Pre-application Medium Development Pre-application Advice Issued

**NCP London Saffron Hill
14 St Cross Street
London
EC1N 8UN**

Proposal: Demolition and redevelopment of current NCP Car Park and erect a new office building (Class E).

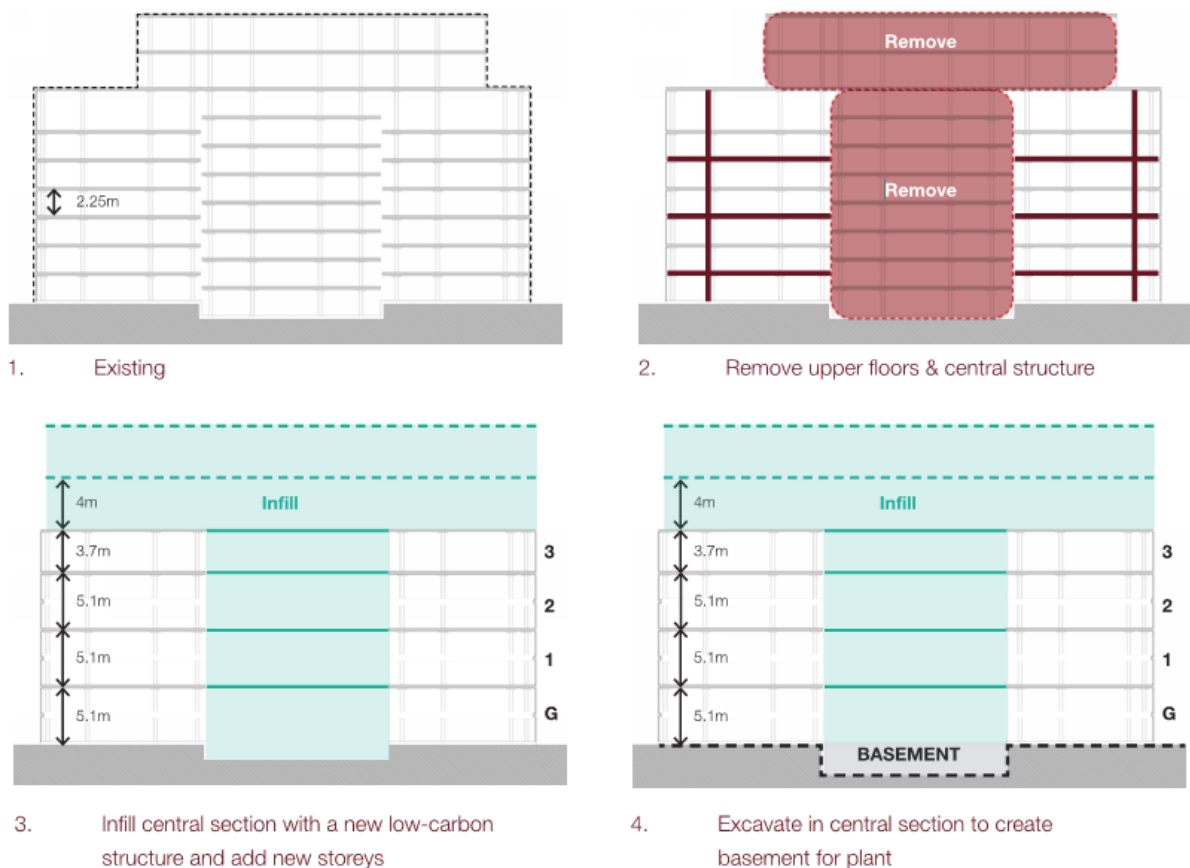
With this option there were still numerous problems and the result would be a scheme that would fail to meet the standards of modern commercial/office space, and would be characterized by inadequate daylight and a poor performance in carbon and energy terms.

With this level of 'refurbishment', the resulting building would still remain compromised and would offer limited scope for future flexibility and reuse.
